GULF STATES UTILITIES COMPANY

June 22, 1984
RBG- 18,090
File Code G9.5, G9.8.6.2

River Bend Station - Unit 1
Docket No. 50-458

Enclosed is Gulf States Utilities Company's (GSU) partial response to the Nuclear Regulatory Commission's (NRC) Safety Evaluation Report (SER) confirmatory item No. (3) identified in Section 2.5.5.2 regarding the factor of safety against failure for all slopes adjacent to the Unit 1 structures. During a telephone conference on June 15, 1984, further clarification was provided to GSU by the NRC's Structural and Geotechnical Engineering Branch (SGEB) reviewer, Mr. Banad Jagannath. The information requested is addressed herein. An additional response addressing the factor of safety against sliding for the service water tunnel (G) that leads to Unit 2 excavation area is scheduled for submittal the week of July 2, 1984.

FIGURE 2.5-72b

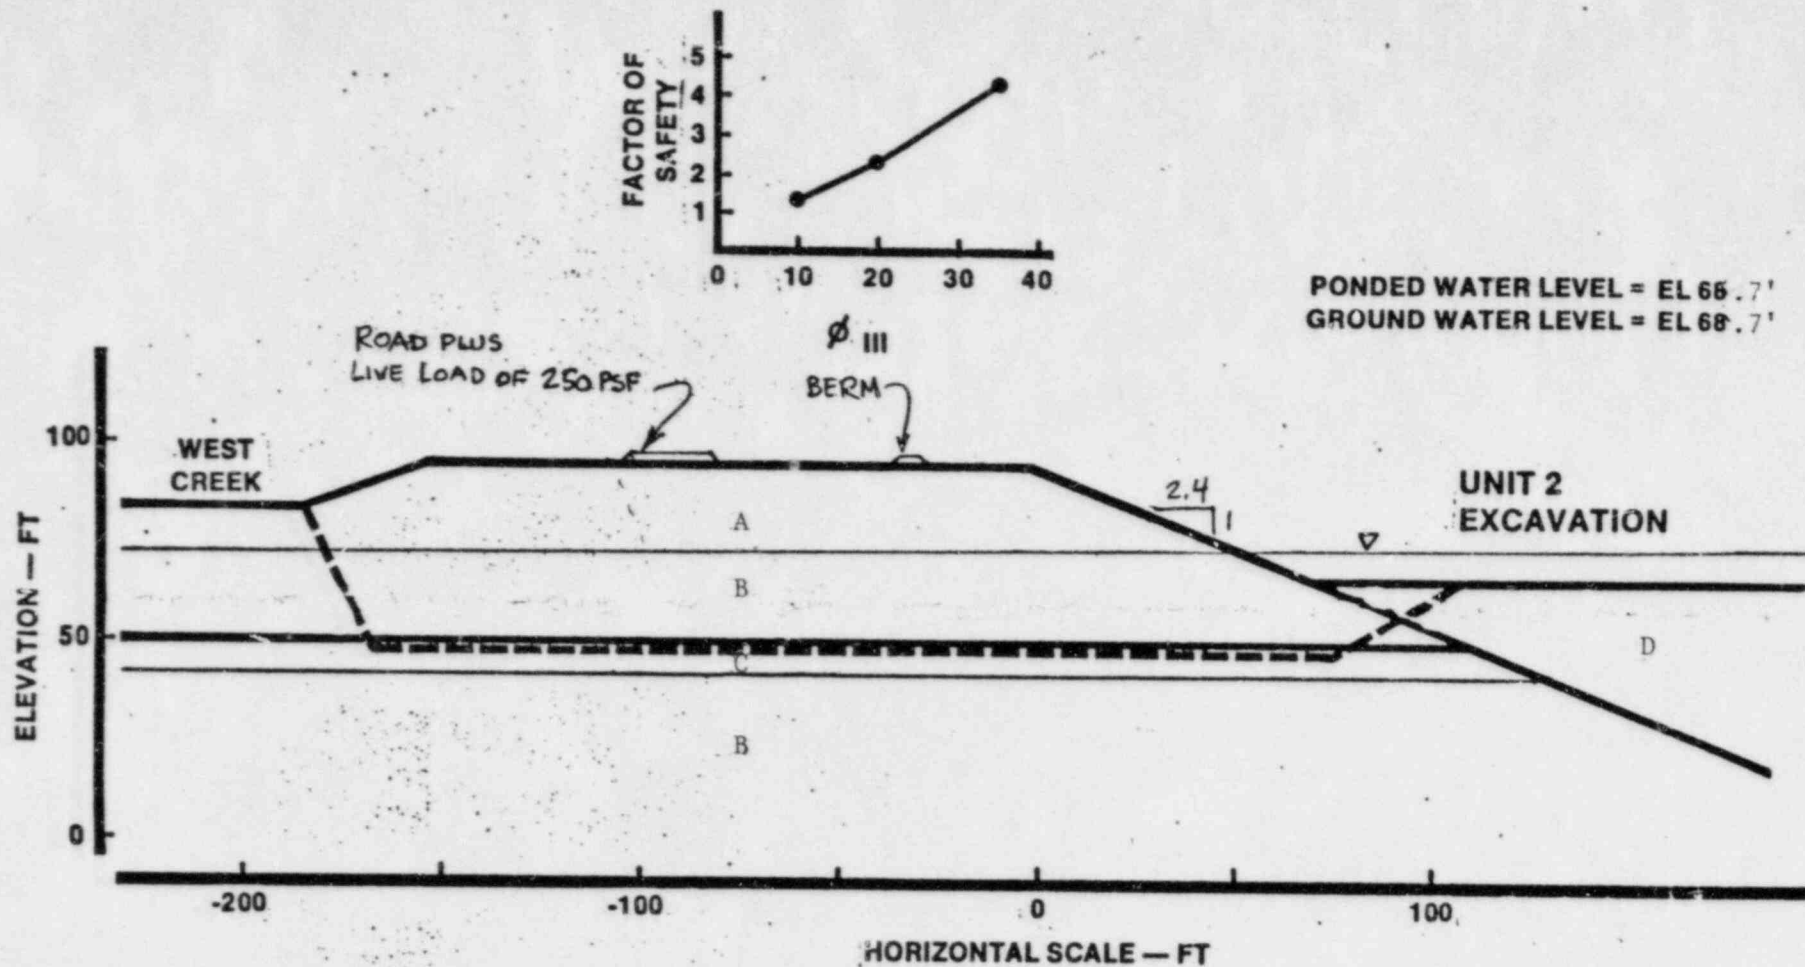
approximately 75 percent, 50 percent, and 0 percent liquefaction, respectively. Fig 2.5-72b shows the geometry that was used to model the west slope.

The massive stability of the west slope was evaluated using the Morgenstern-Price Method. In this case, the critical factor of safety corresponds to the SSE loading; therefore, results are presented only for the SSE case.

Given the adequate factors of safety for these two conditions, it is concluded that the safe operation of Unit 1 is not impacted by the slopes associated with the Unit 2 excavation. The results of the Morgenstern-Price analysis for SSE loading are summarized on Fig. 2.5-72b. The analysis shows that for the extremely unlikely event of liquefaction of 75 percent of the soils at elevation 50 ft msl (corresponding to $\phi_{III}=10$ deg) the factor of safety against sliding is approximately 1.3. Given the conservatism of the analysis that results in a factor of safety of 1.3, it is concluded that the cut slopes of the Unit 2 area are stable.

FIGURE 2.5-72C
 SUMMARY OF SLOPE STABILITY ANALYSIS
 UNIT 2 EXCAVATION BACKFILL SLOPES
 SIMPLIFIED BISHOP - ALL LOADINGS
 RIVER BEND STATION
 FSAR

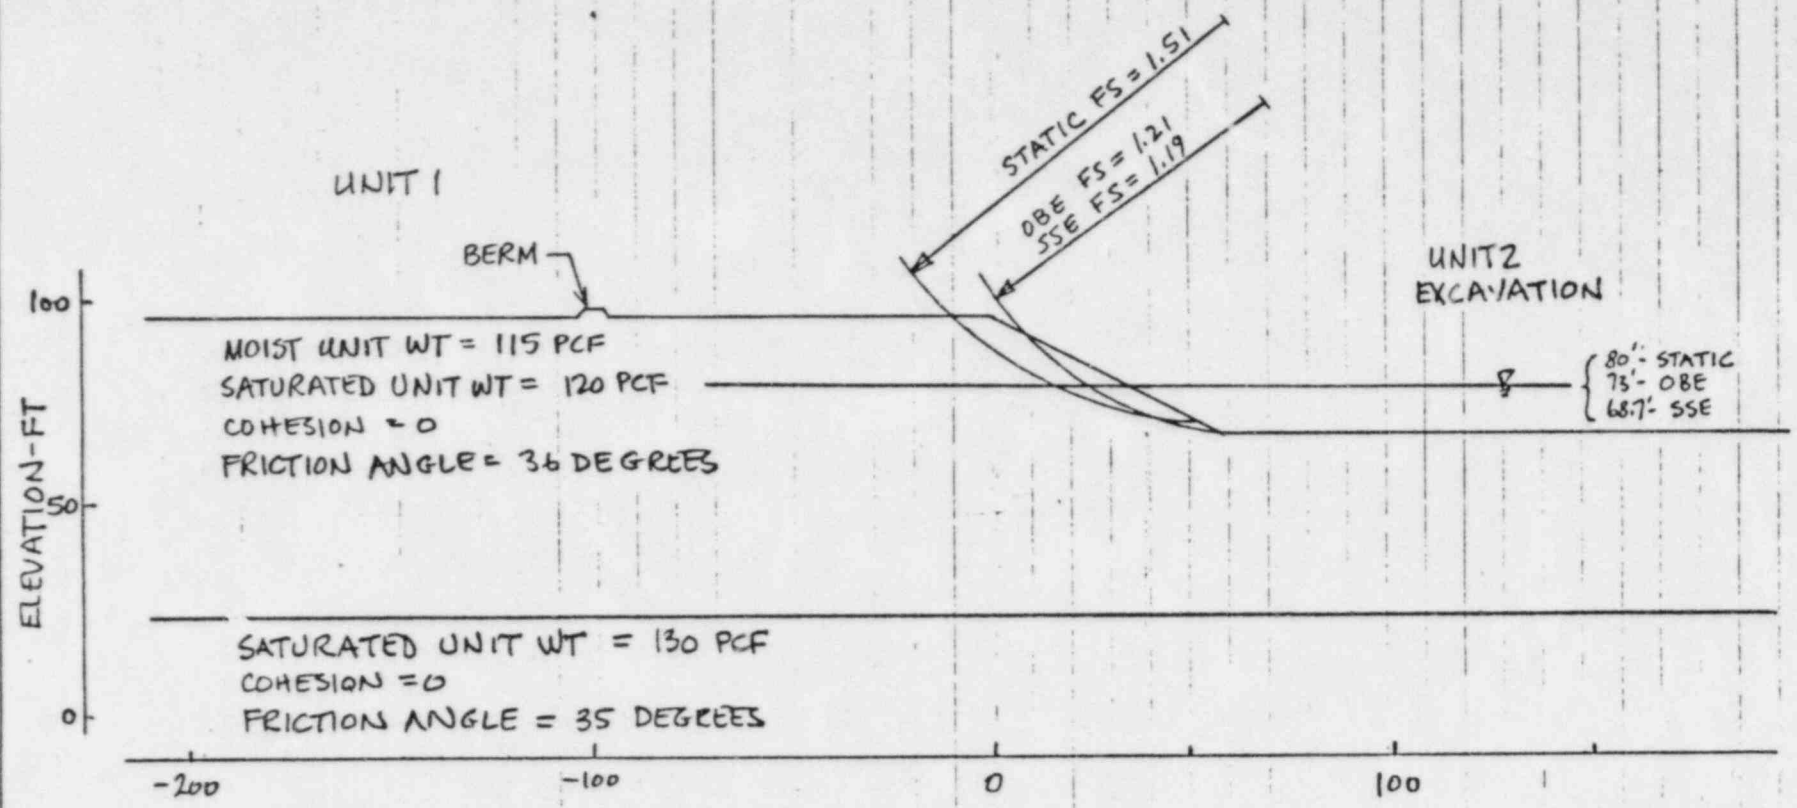
The slopes located east of Unit 2 were analyzed using the simplified Bishop Method. Since these slopes are constructed of engineered backfill as described in Section 2.5.4.5.3, no liquefaction was postulated. The geometry analyzed and typical results of the computerized calculation are shown on Fig. 2.5-72c. In general, for trial circles at the same center, the factor of safety decreases with decreasing radius, indicating that the critical factor of safety corresponds to an infinite slope type failure. Analysis of the infinite slope problem under SSE loading gives a factor of safety of 1.12 which corresponds to minor surficial sloughing at the face of the slope. This analysis is based on a friction angle of the backfill material equal to 36 deg. Laboratory testing of backfill samples (Appendix 2M - Triaxial S Tests) indicate that for backfill compacted to 89 percent relative density a friction angle of 42 deg can be justified. Using a friction angle of 42 deg in the infinite slope analysis results in a factor of safety of approximately 1.4. Failure surfaces large enough to breach the berm have factors of safety in excess of 3. It is concluded that the backfill slopes east of the Unit 2 excavation are stable.

FIGURE 2.5-72 d

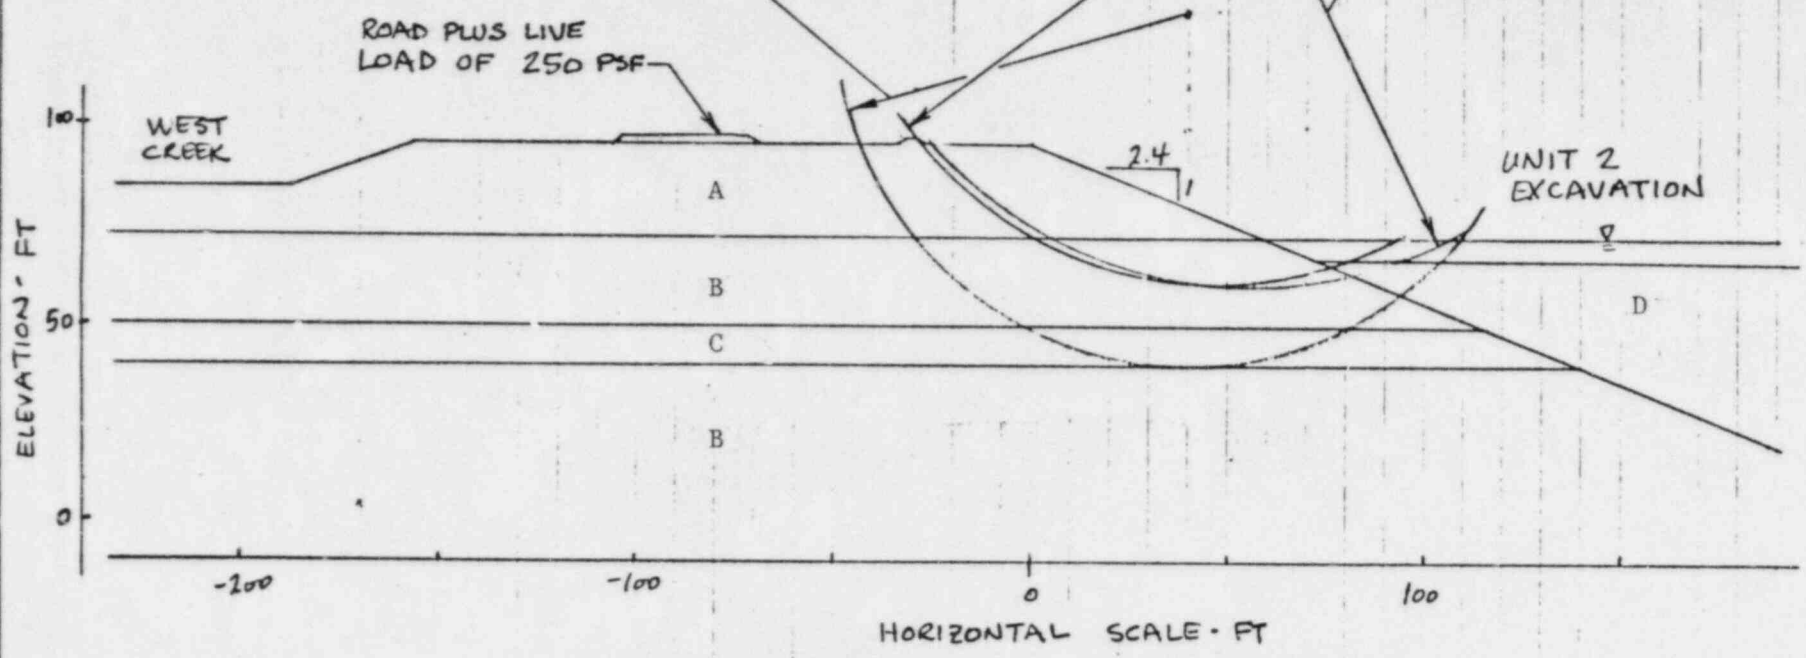
Since the berm is not required during a 25-yr storm + SSE, the berm is located so that it is stable during the OBE. The berm location based on the OBE analysis is then used in subsequent analyses of slope stability.

The local stability of the face of the cut slopes under the OBE loading was evaluated using the simplified Bishop Method. The geometry analysed and typical results of the computerized calculation are shown in Figure 2.5-72d. Also shown in that figure, is the factor of safety against an infinite slope failure under all loading conditions. It is concluded that the face of cut slopes is stable under the OBE and static conditions. Under SSE loading, analysis shows in stability at the face of the slope which may breach the berm. However, as stated in Section 2.5.5.2.1 safe operation of Unit 1 would not be affected.

FIGURE 2.5-72a
 PLANT EXCAVATION BACKFILL PLAN WITH BERM
 RIVER BEND STATION
 FINAL SAFETY ANALYSIS REPORT

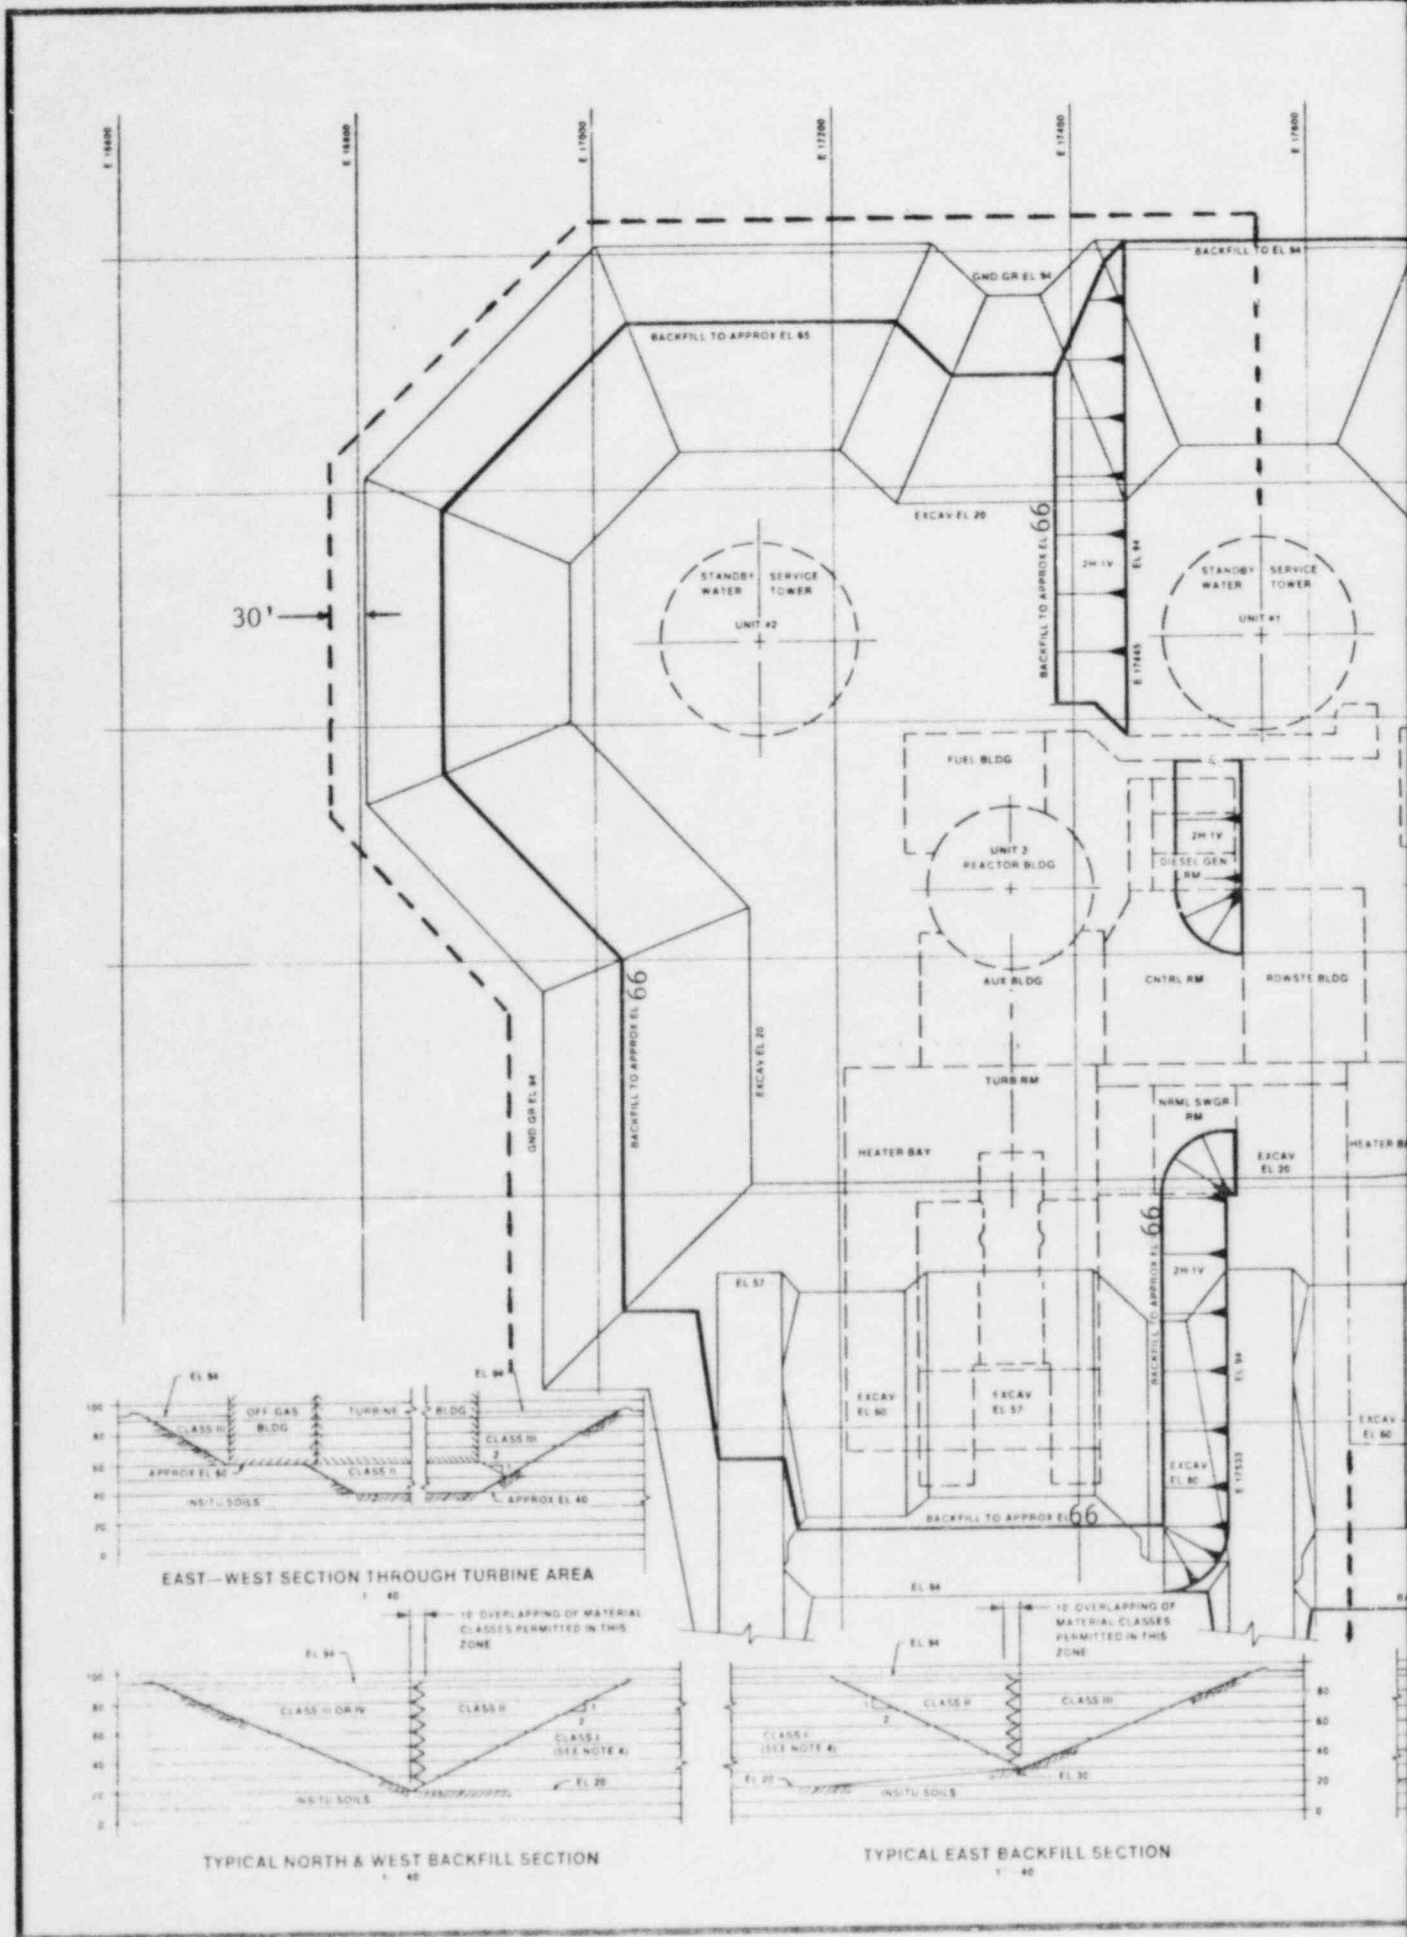
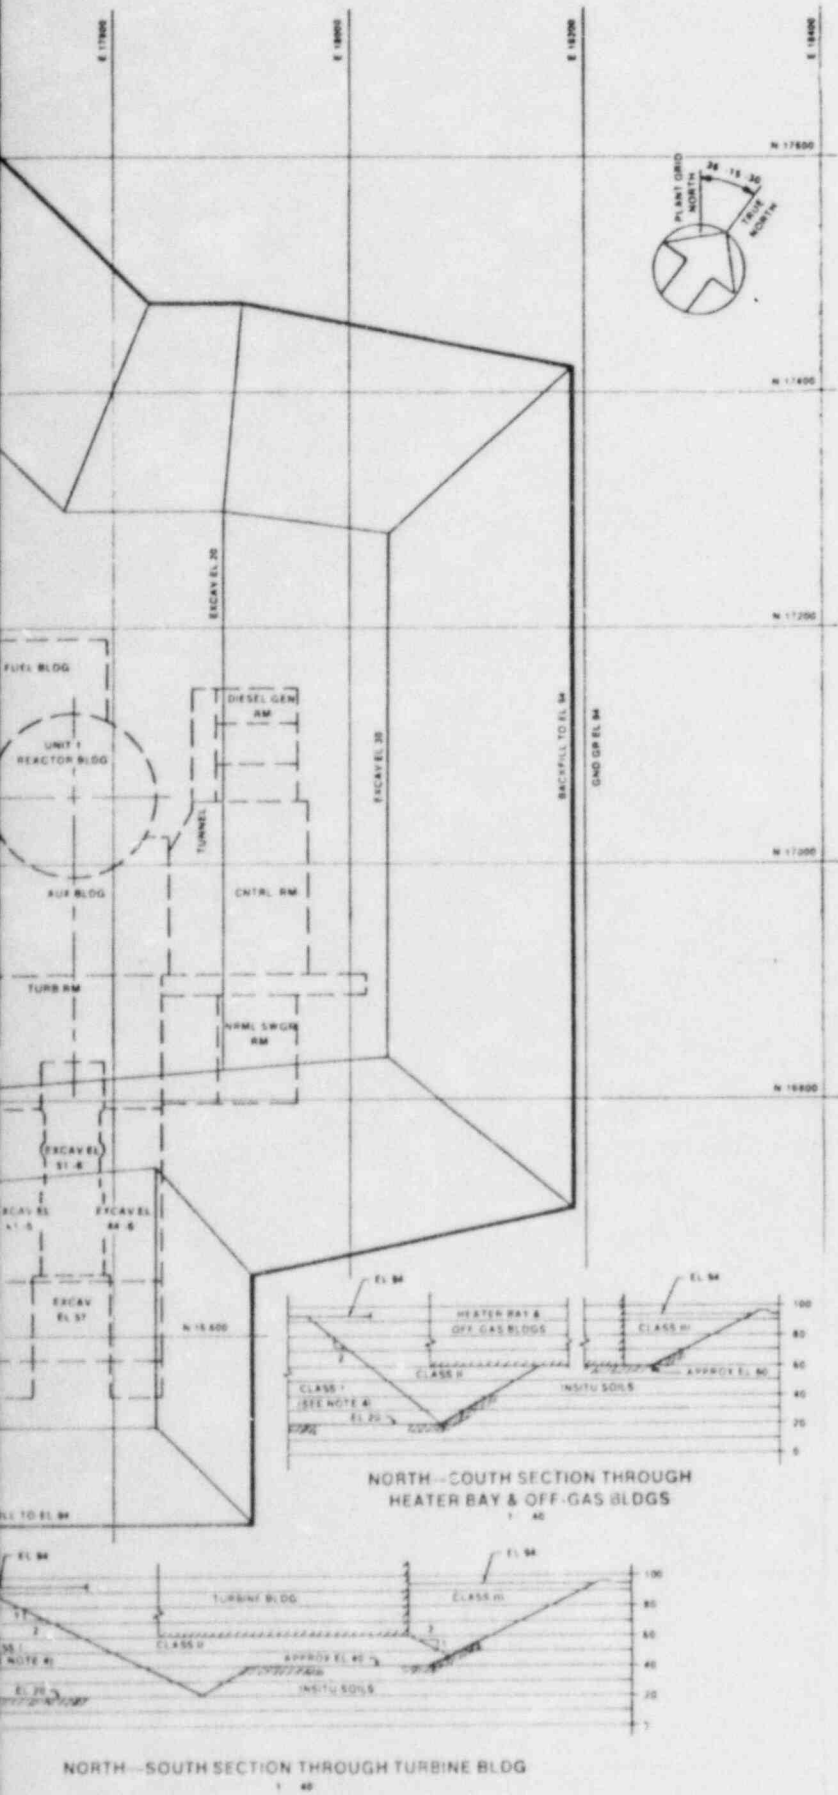
The slopes ^{and berm location} in the Unit 2 excavation are shown in plan on Fig. 2.5-72a. The slopes located to the north, west, and south of the Unit 2 area are cut slopes in natural soils. The slopes located east of the Unit 2 area are constructed of backfill.

As described in Section 2.4, a berm is used to control the ponded water levels in the Unit 2 excavation. However, analysis of the 25-yr rainfall event + SSE without the berm in place indicates that a ponded water level of el. 68.7 ft msl would result in the Unit 2 excavation. For the 1/2 PMP + OBE and for the 1/2 PMP followed by the PMP (which is considered without a seismic event) the berm is required in order to maintain a ponded water level below the design basis ponding level (el. 80 ft msl) in the excavation. Should an SSE result in disruption of the berm, the berm will be restored.
